Addendum 3 for RFB927940-04

Project Name: WRC Decentralization Phase 4 & Fire Alarm Phase 3 (9279.40 & 9279.41) Bid Issuance #4
DAS RFB #: 927940-04
DAS Project #: 9279.40 & 9279.41
Date: 6/2/2026

13-M400

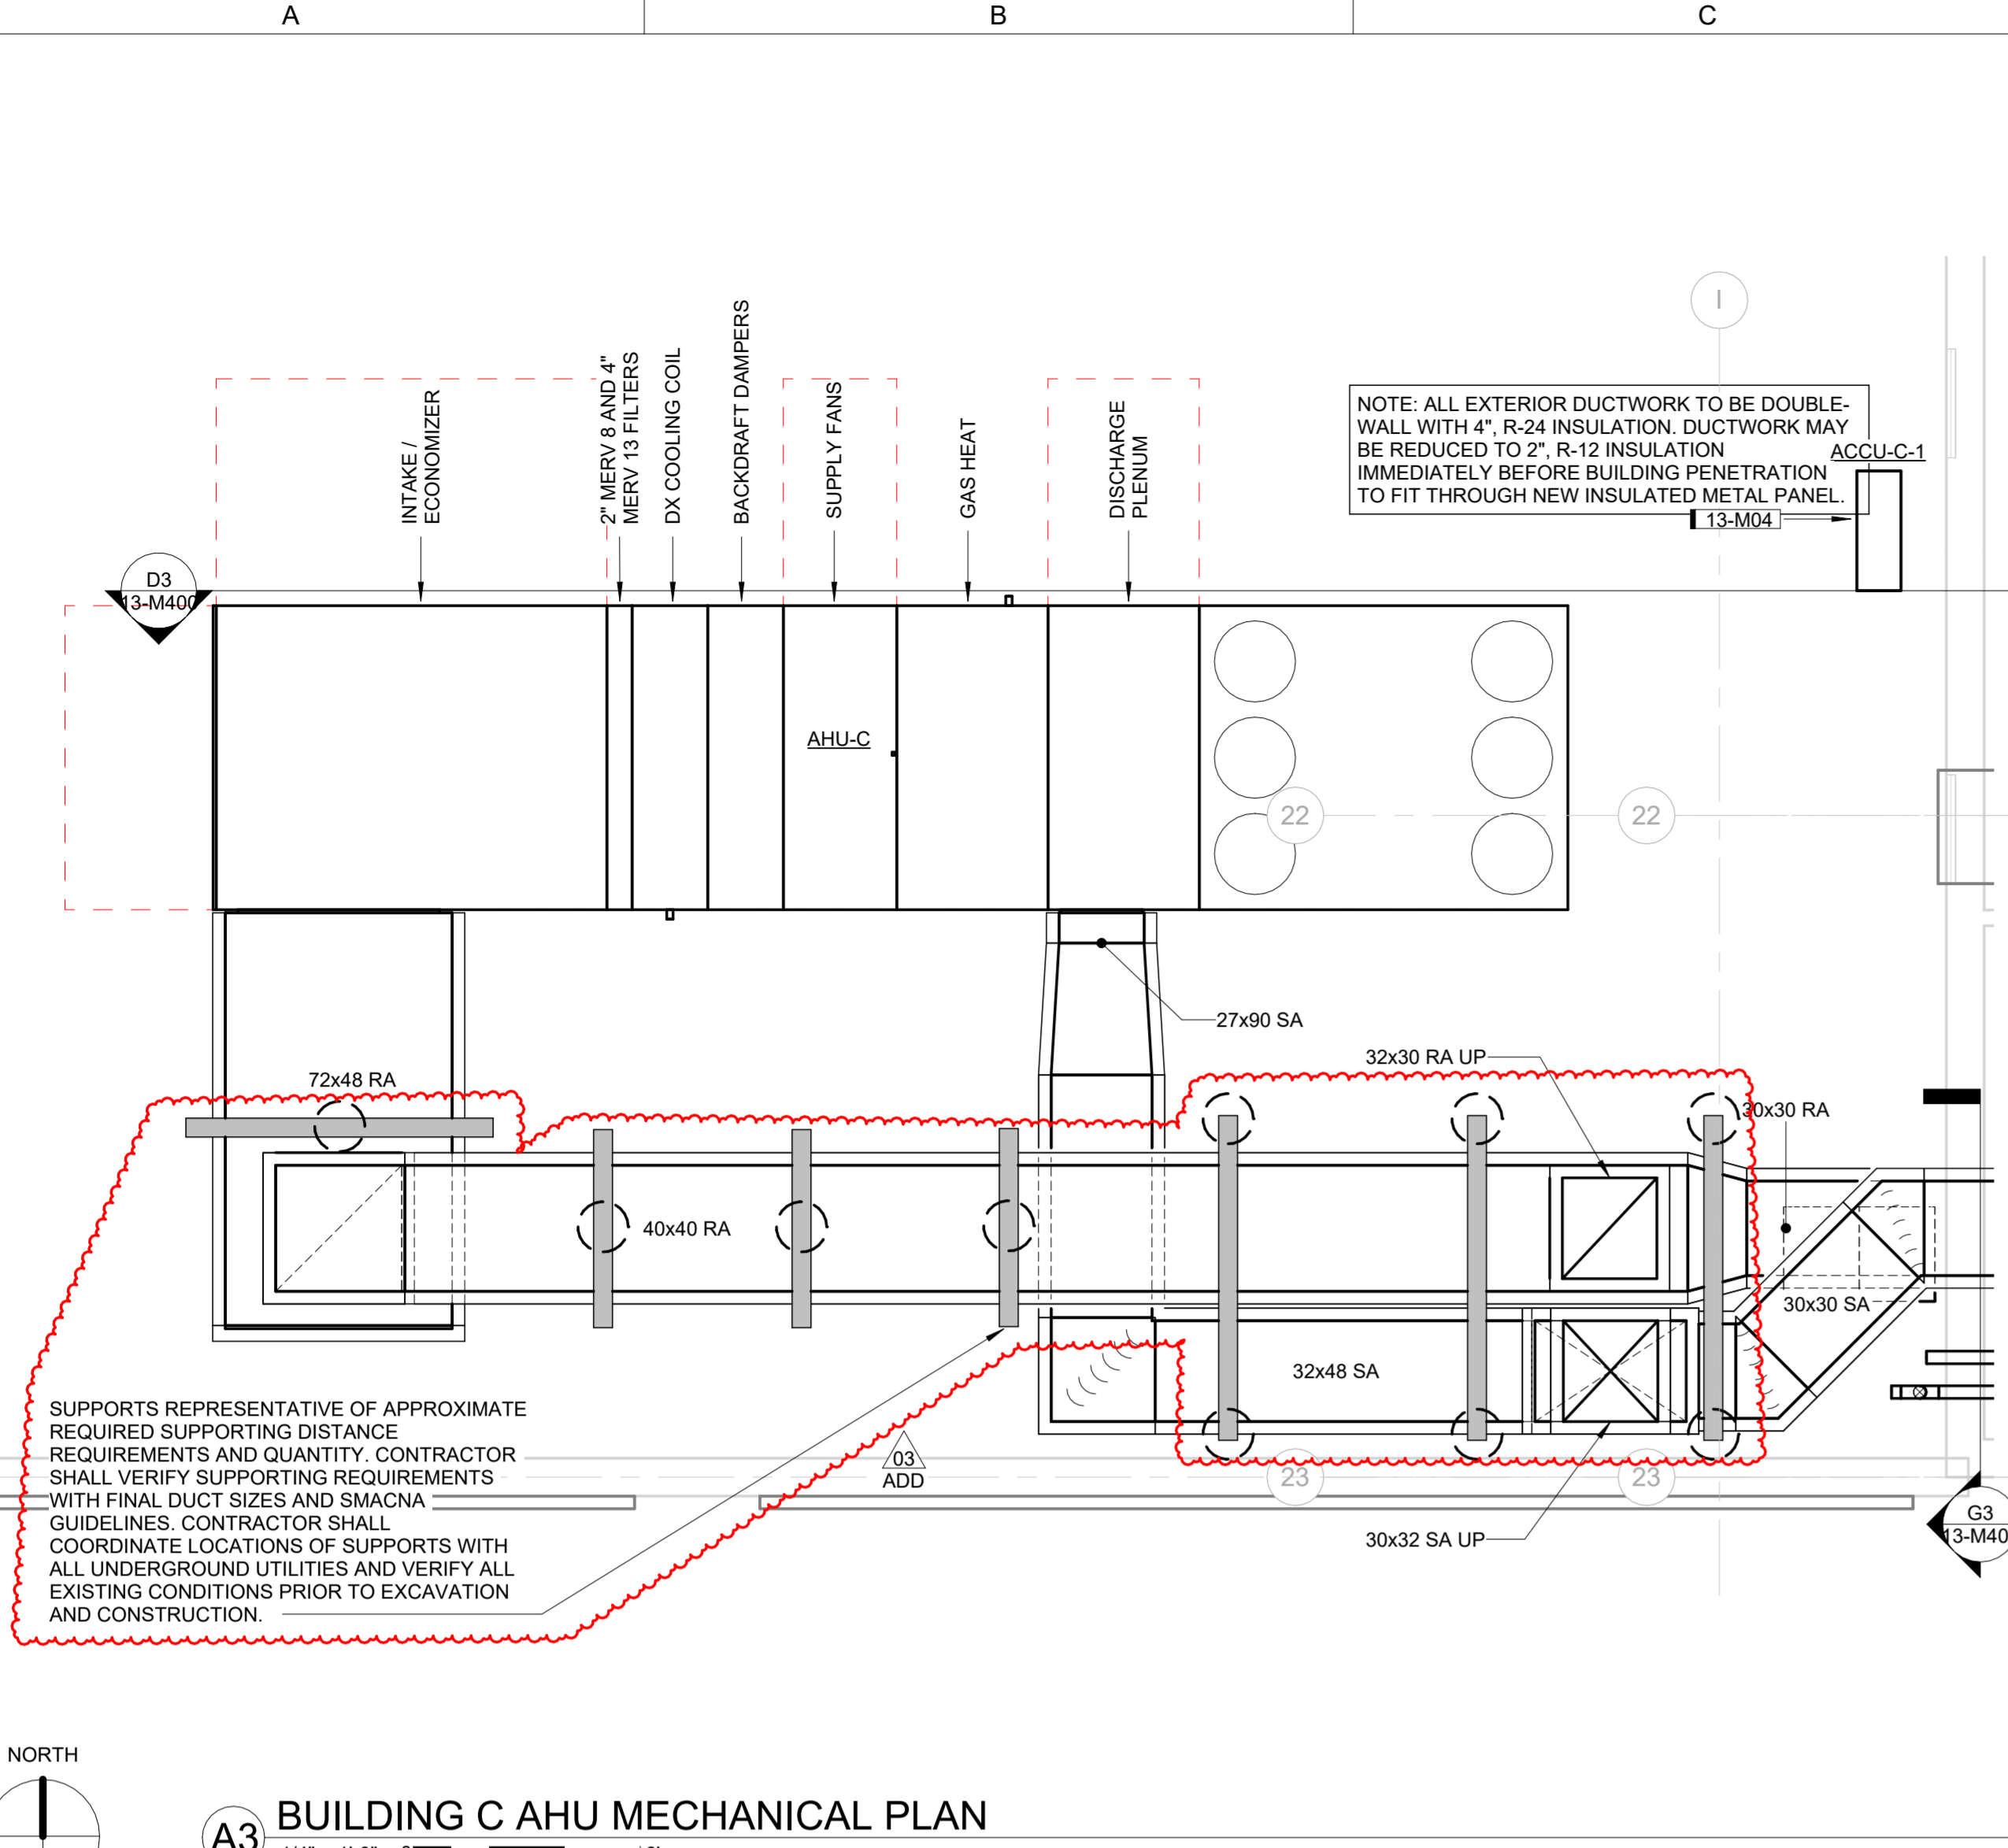
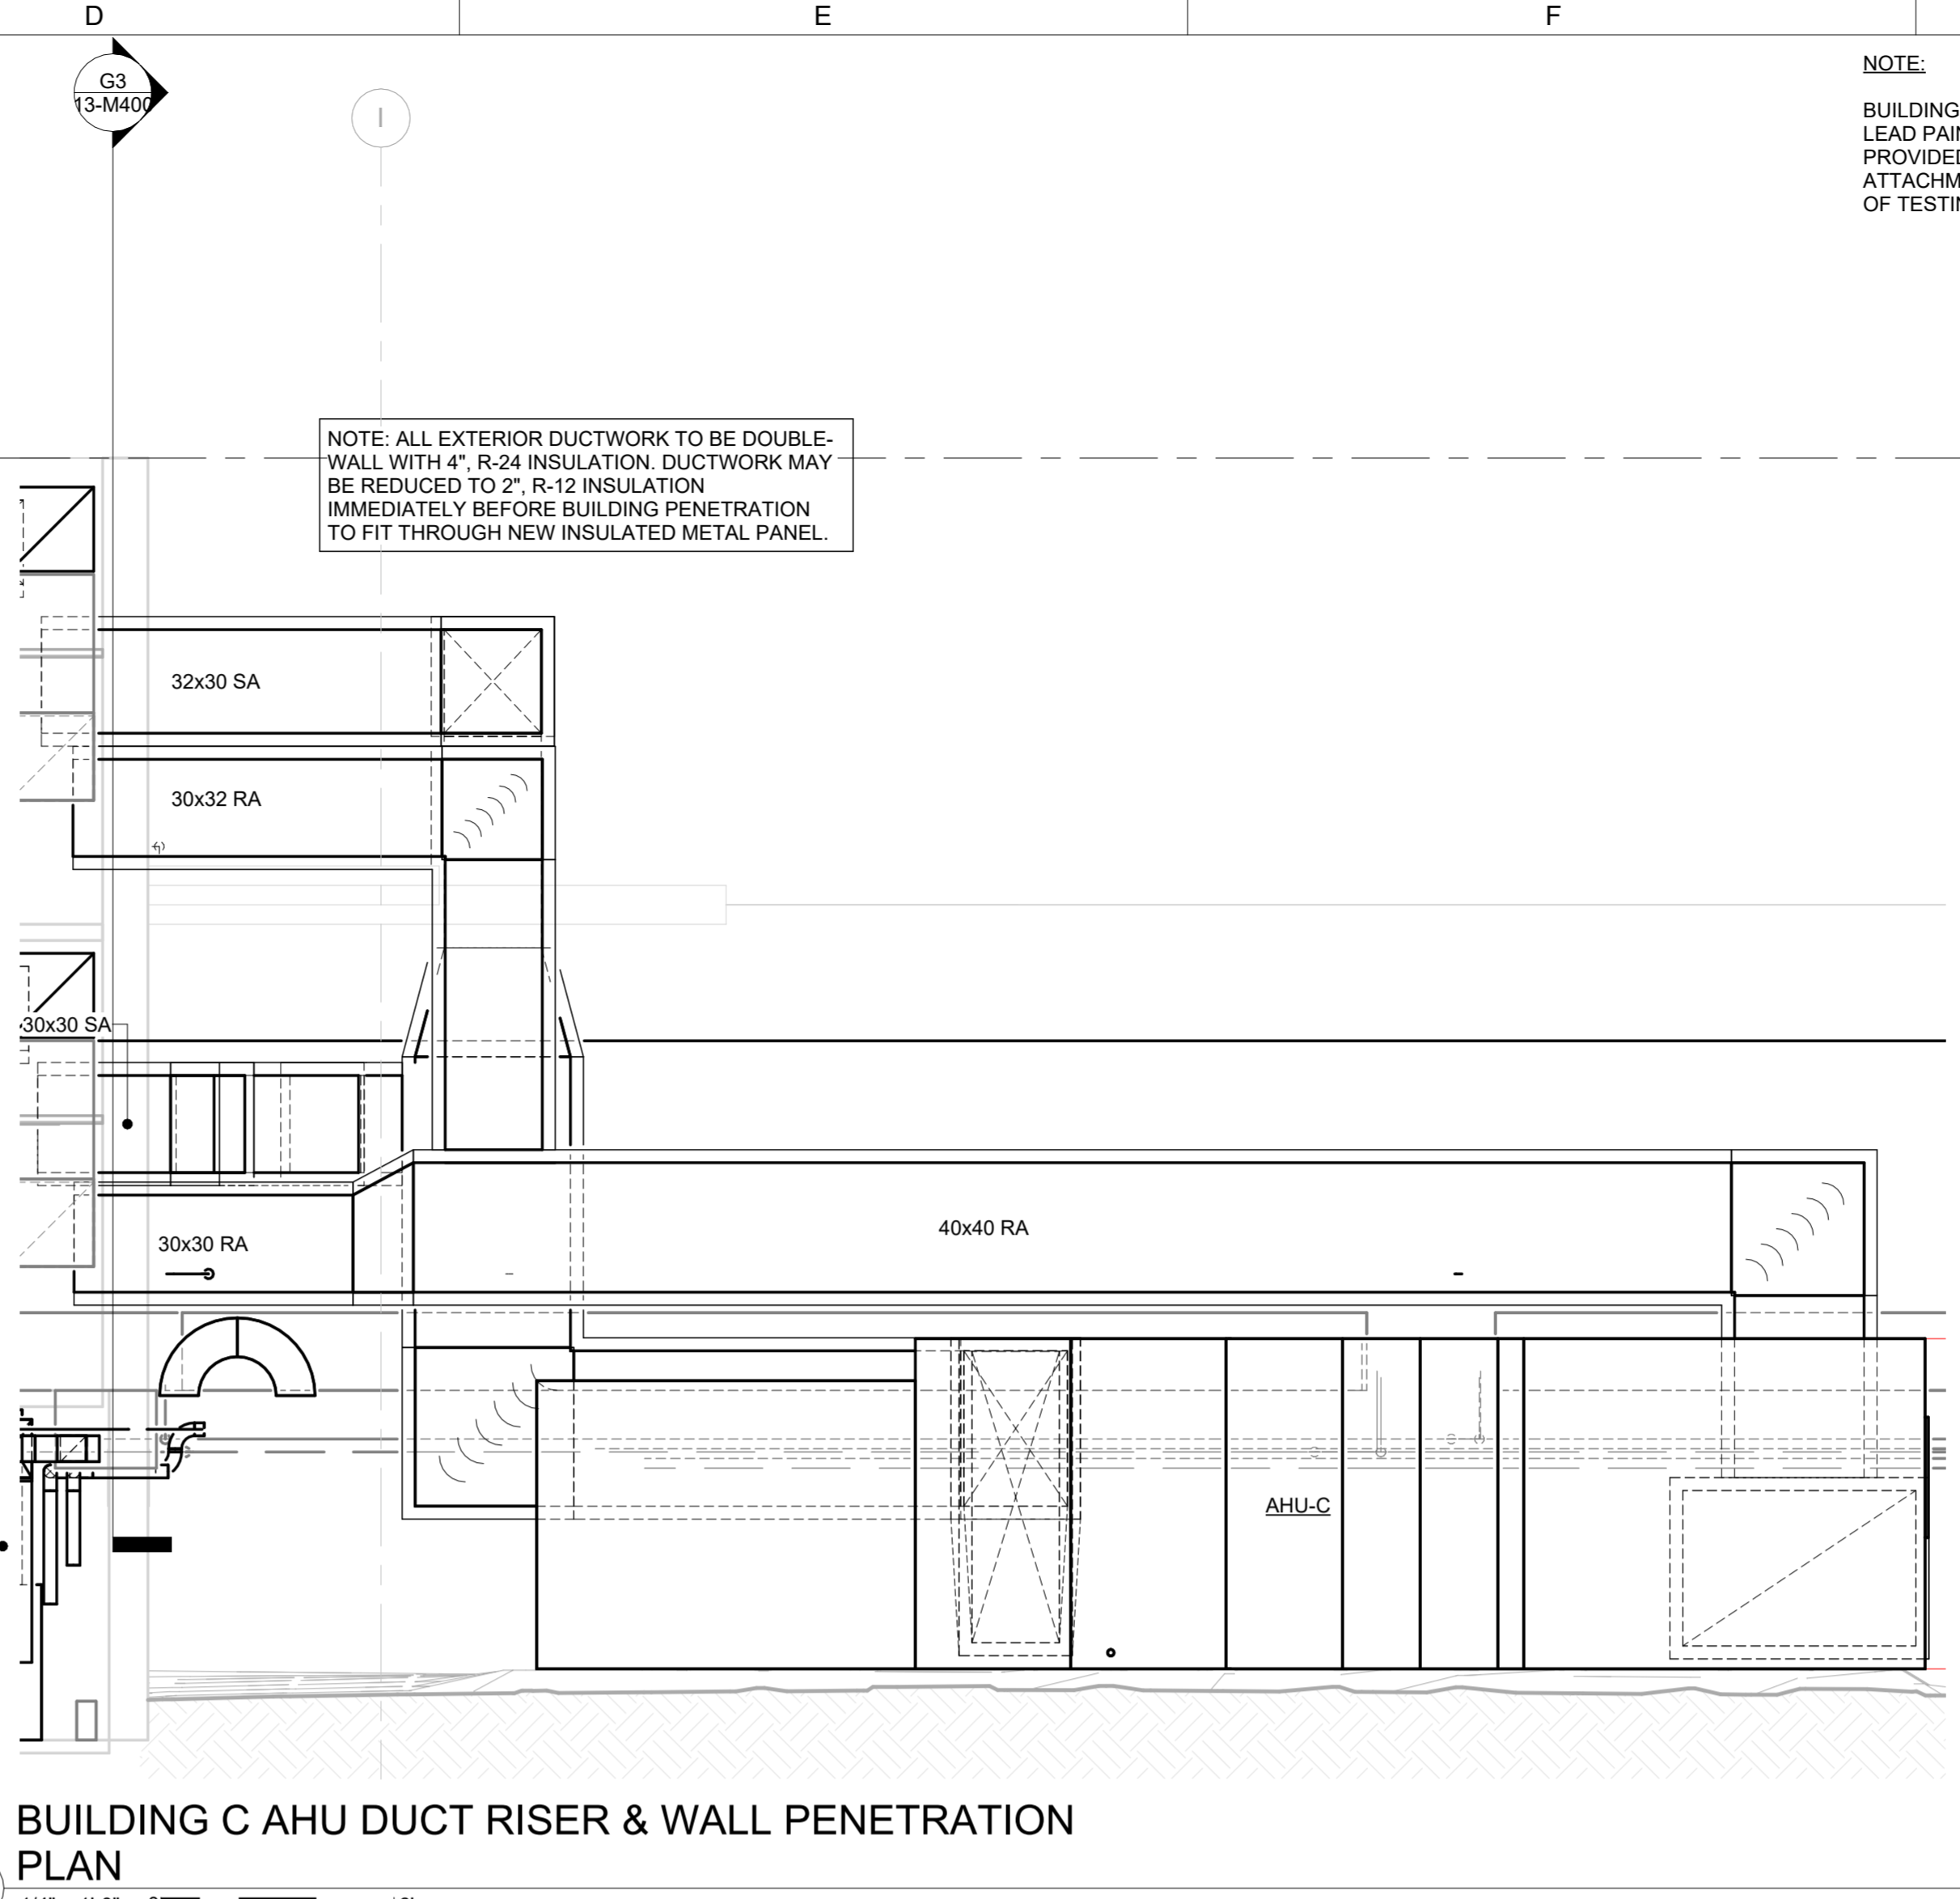
- **13-M300 – THERMOSTAT PLAN:**
 - **ADD** Tags to EUH-D-2 and ACCU-D-2.
- **13-M400 – BUILDING C & D ENLARGED AHU PLANS:**
 - **ADD** Approximate duct support locations to exterior ductwork and associated note “SUPPORTS REPRESENTATIVE OF APPROXIMATE REQUIRED SUPPORTING DISTANCE REQUIREMENTS AND QUANTITY. CONTRACTOR SHALL VERIFY SUPPORTING REQUIREMENTS WITH FINAL DUCT SIZES AND SMACNA GUIDELINES. CONTRACTOR SHALL COORDINATE LOCATIONS OF SUPPORTS WITH ALL UNDERGROUND UTILITIES AND VERIFY ALL EXISTING CONDITIONS PRIOR TO EXCAVATION AND CONSTRUCTION.”
